TECHNICAL EVALUATION REPORT

CONTAINMENT LEAKAGE RATE TESTING

NORTHERN STATES POWER COMPANY  
MONTICELLO NUCLEAR GENERATING PLANT

NRC DOCKET NO. 50-263

Figure 1. Drywell Spray Line.

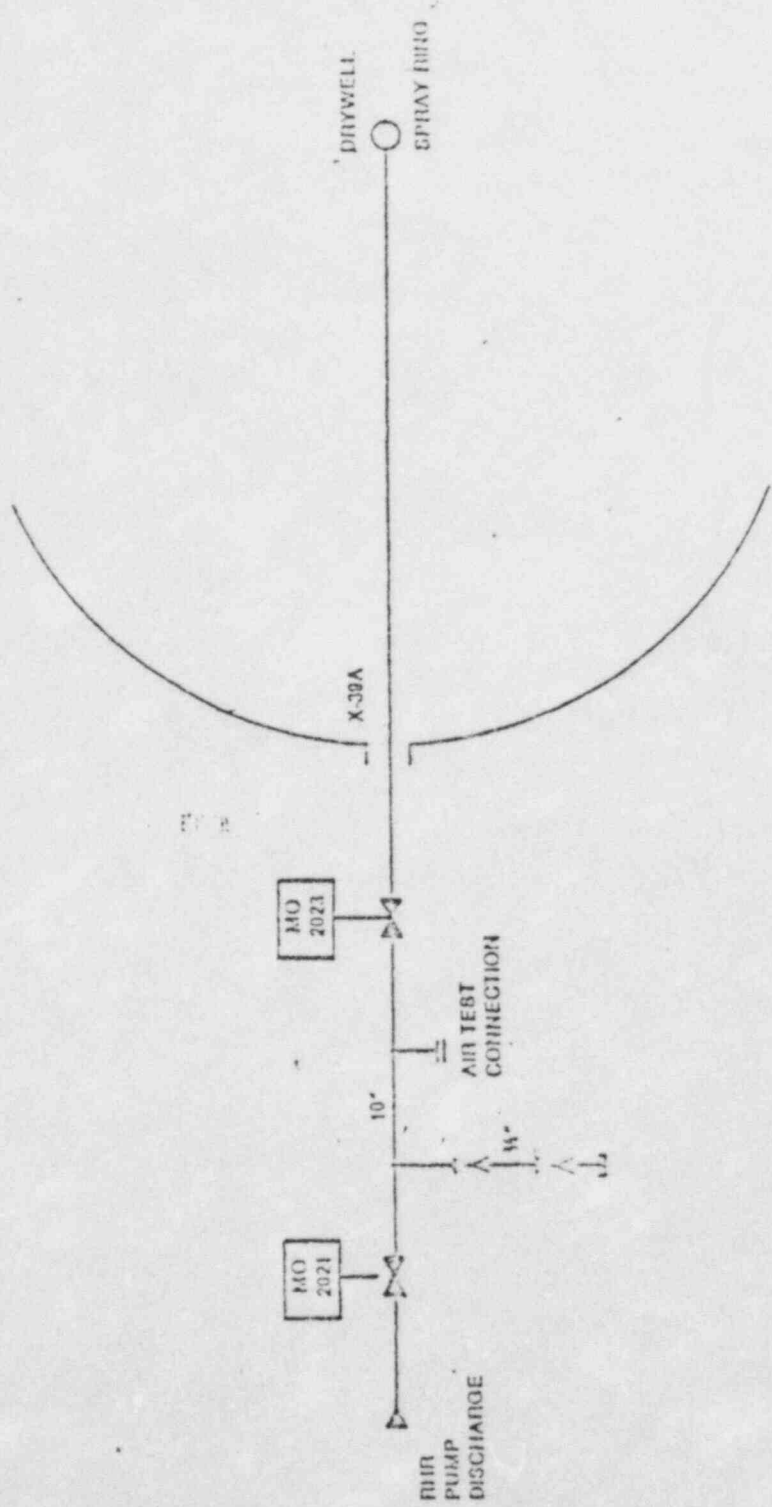
NRP's contention that this line does not constitute a containment leakage path because it is always pressurized by the RER pumps in a post-accident configuration is correct only in that valve MO-2021 is constantly under RER pump pressure (see Figure 1). Since valves MO-2021 and -2023 are initially shut and remain shut until manually opened by an operator (in order to initiate drywell spray), there is no guarantee that the line between the valves will normally be pressurized or even water-filled.

Valves MO-2021 and -2023 are normally shut valves. They are checked-shut by the safety-injection signal at the start of an accident. This is done to ensure that all low pressure injection flow is initially directed into the reactor vessel and not diverted to drywell spray. Once reactor vessel level has been reestablished, the valves receive an open-permissive signal so that the operator may initiate drywell spray to prevent excessive drywell pressure. Depending upon the extent of increase in drywell pressure, spray may or

may not be initiated. Consequently, the status of the piping between the valves (water-filled, air-filled, pressurized, etc.) cannot be conclusively stated and, for purposes of conservatism, the piping should be considered to be air-filled.

Valves MO-2021 and -2023 are single-wedge gate valves. In the case of valve MO-2021, the RHR water pressure on the upstream side of the disc will cause the downstream side to be forced against its seat, unseating the upstream seating surfaces by the tolerance machined into the disc, at a minimum. This design prevents potential leakage of containment air both by improving the seal of the downstream seat and disc and by pressurizing the valve packing and body-to-bonnet seal with water at pressures greater than peak containment pressure.

In the case of valve MO-2023, however, the valve packing area and the body-to-bonnet seal area may be exposed to containment air pressure since the water seal is not present against this valve. In this case, containment air can escape to the outside atmosphere through either the valve packing or the body-to-bonnet seal.

Since valve MO-2023 can become a source of leakage of containment air to the outside atmosphere, it must be Type C tested in accordance with the requirements of Appendix J. However, since the only potential sources of leakage are the packing and body-to-bonnet areas, the intent of Appendix J is satisfied if these areas are tested in accordance with Appendix J procedures. As can be seen in Figure 1, this testing can be performed by pressurizing the piping between valves MO-2021 and -2023 with air, assuming all detected leakage to be outleakage through the packing or body-to-bonnet seal.

The Licensee should take action to ensure that the intent of Appendix J is satisfied with regard to valve MO-2023 (and similarly valve MO-2022 in the case of penetration X-39B).

Figure 2. Torus Spray and Recirculation Lines.

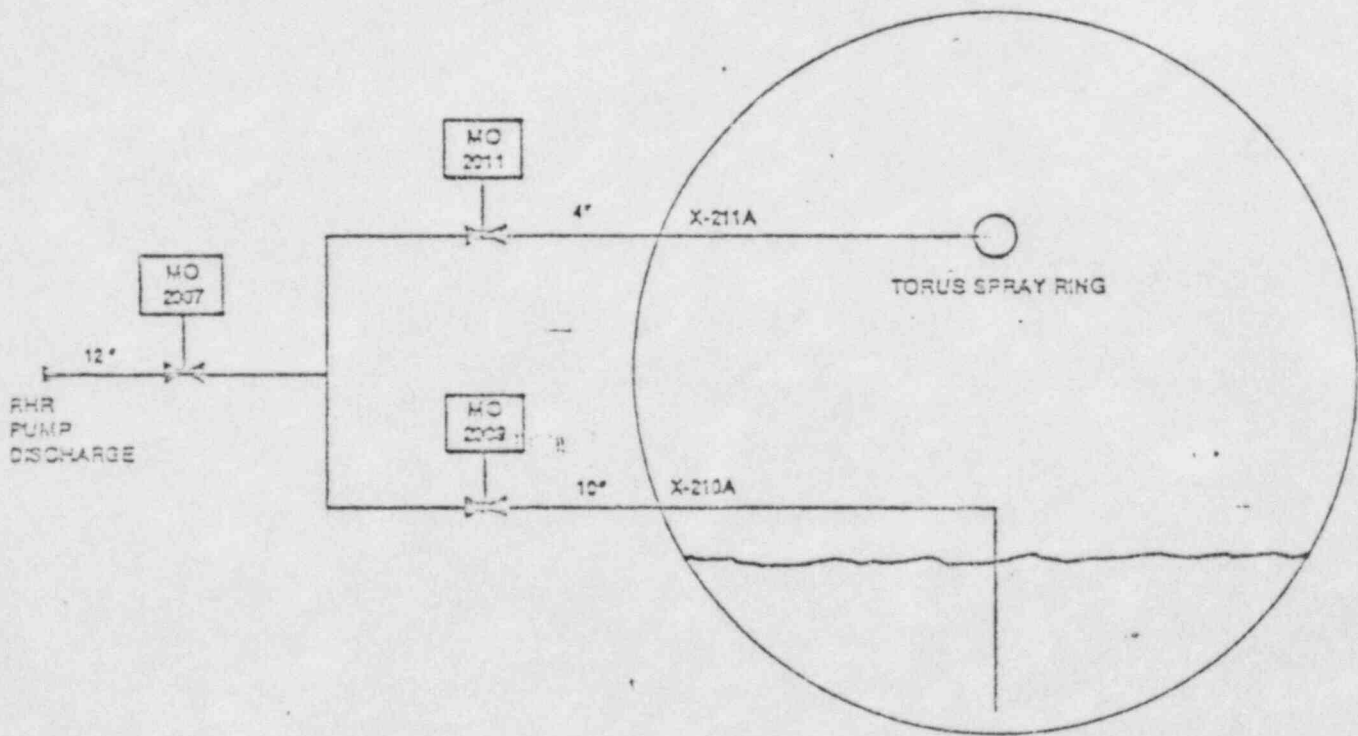
As discussed in Section 3.1.3.1, it is not possible to conclusively determine whether the line between valves MO-2007 and MO-2011 will be

pressurized, water-filled, or air-filled (Figure 2). Unlike the drywell spray line, however, valve MO-2011 is not a single-wedge gate valve but is a globe valve. Without a detailed drawing of valve MO-2011, it cannot be determined on which side of valve MO-2011 the packing is located. Nevertheless, the basic principles involved in the discussion associated with the drywell spray line apply to the torus spray line.

In view of the discussion associated with the drywell spray line and in view of the fact that valve MO-2011 is a globe valve, it is concluded that valve MO-2011 (and similarly MO-2010 in the case of penetration X-211B) should be tested in the direction of its safety function in accordance with Type C testing procedures or should be tested in accordance with Type C testing procedures from any direction which will result in a test of the valve packing and body-to-bonnet seal areas. Valve MO-2007 (and similarly MO-2006 in the case of penetration X-211B) does not require testing because of the water seal supplied by the RHR pumps.

As can be seen from Figure 2, it is not possible for containment atmosphere to enter the torus recirculation line because the line terminates below the water level of the suppression pool. In this case, regardless of the location of the packing of valve MO-2009, there is no potential path for leakage of containment atmosphere through the recirculation line. Consequently, valve MO-2009 is not a containment isolation valve in accordance with the definition in Section II.B of Appendix J with regard to the recirculation line. However, it should be observed that, with regard to the torus spray line, the packing of valve MO-2009 can be a potential source of atmospheric leakage if valve MO-2011 is open or leaking past its seat and the packing of valve MO-2009 is exposed to the pressure from that direction (see Figure 2).

Valve MO-2009 (and, similarly, MO-2008 in the case of penetration X-210B) does not require Type C testing with regard to the torus recirculation line because this testing is not required by Appendix J. However, if the packing of this valve (and, similarly, MO-2008) is exposed to leakage coming from the

wards spray line, the packing of this valve should be tested in accordance with Type C procedures.

Figure 3. Penetration X-16A.

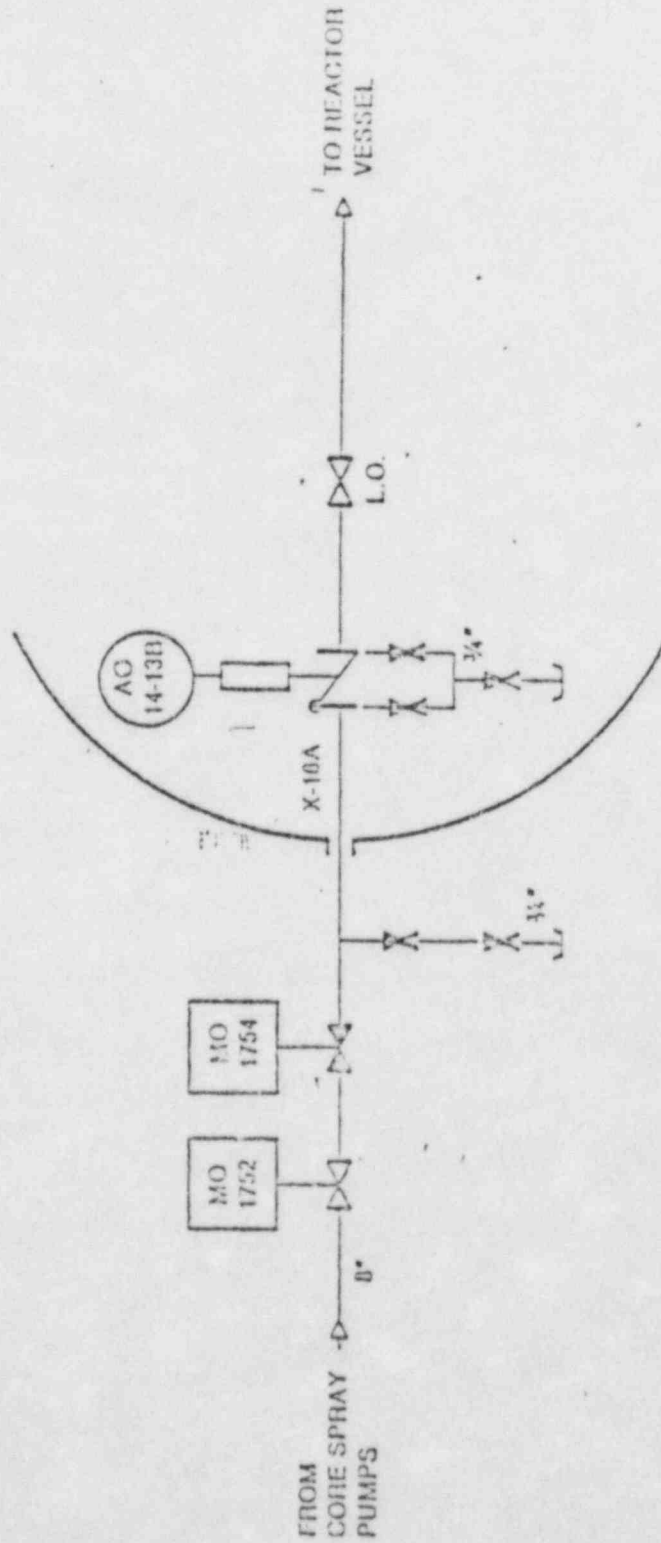
In this case, there is no possibility for leakage of containment atmosphere. However, if a core spray pump fails to start, the testable check valve would be relied upon to prevent leakage of containment atmosphere if the liquid inventory of the system is exhausted by integrated system leakage before the Type C-tested motor-operated isolation valves are shut. In the case of penetration X-16A (Figure 3), valves MO-1752 and MO-1754 would have to be shut. The configuration of the other core spray penetration (X-16B) is essentially identical to the piping configuration of Figure 3.

NSP contends that it is unlikely that the piping outside containment will fail because of the reliable design of the system. This contention is acceptable, even though there are non-safety-related connections to the core spray system (e.g., the condensate service water system), because, in each instance, the safety-related and non-safety-related boundaries are separated by at least two safety-related check valves in series or a locked-shut safety-related manual isolation valve. Furthermore, periodic inservice testing of the core spray system provides additional assurance that the liquid inventory of the system will not be exhausted before the operator can discover the failure of a pump and either establish flow or shut the motor-operated isolation valves prior to the onset of atmospheric leakage. The core spray check valves are located inside containment, and therefore seat leakage is the only leakage of concern. Type C testing of the motor-operated valves (MO-1752 and MO-1754 in the case of penetration X-16A) will account for any seat leakage path check valve AO-14-13B.

It is concluded that the core spray testable check valves (AO-14-13A and AO-14-13B) are not relied upon to prevent the escape of containment air to the outside atmosphere. This conclusion is based on the determination that, under normal circumstances, containment outleakage is absolutely precluded by operation of the core spray system and, in the unlikely event that a core spray pump fails to start, the design features of the system and periodic inservice testing provide adequate assurance that the Type C-tested motor-operated isolation valves can be shut prior to the onset of containment atmospheric leakage.

Figure 4. Penetration X-13A.

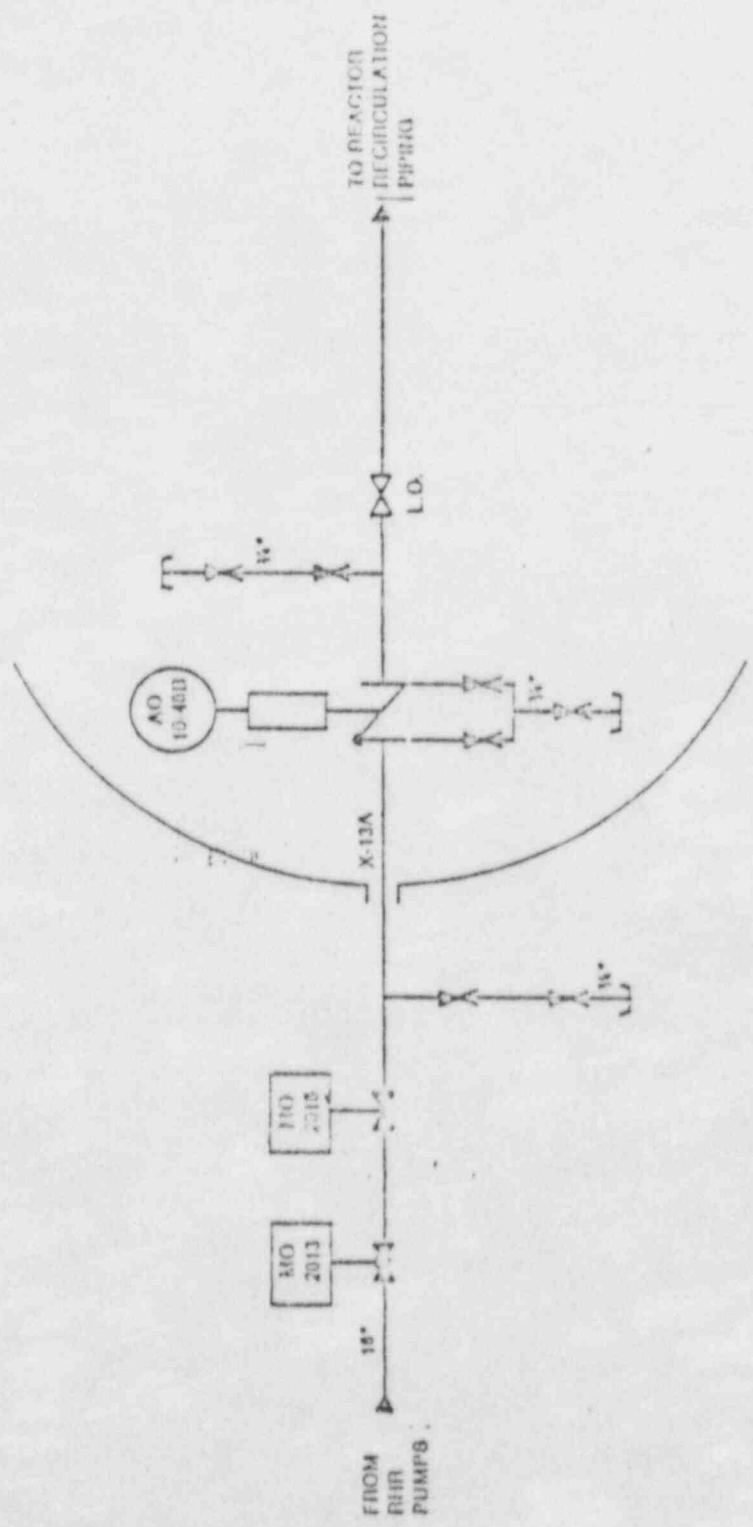
In the unusual case that one of the LPCI loops is intentionally secured while containment integrity is still of concern, motor-operated isolation valves outside containment would be shut. In the case of penetration X-13A (Figure 4), valves MO-2013 and MO-2015 would be shut. The configuration of the other LPCI penetration (X-13B) is essentially identical to the piping configuration of Figure 4.

As can be seen from Figure 4, valves MO-2013 and MO-2015 are capable of isolating any leakage past the testable check valve AO-10-46B. Since they will be tested in accordance with Type C testing procedures, the requirements of Appendix J will be satisfied. Because of the testing of MO-2013 and MO-2015, testable check valve AO-10-46B is again not relied upon to perform a containment isolation function and therefore Type C testing of this valve is not necessary. A similar situation exists for testable check valve AO-10-46A, where the other LPCI cooling loop is secured.

In view of the preceding, it is concluded that the LPCI testable check valves are not relied upon to perform a containment isolation function, whether the LPCI cooling loop is in operation or not, provided that the motor-operated isolation valves outside containment are Type C tested as required by NSP. In this case, valves AO-10-46A and AO-10-46B do not require Type C testing in accordance with Appendix J and no exemption is necessary.
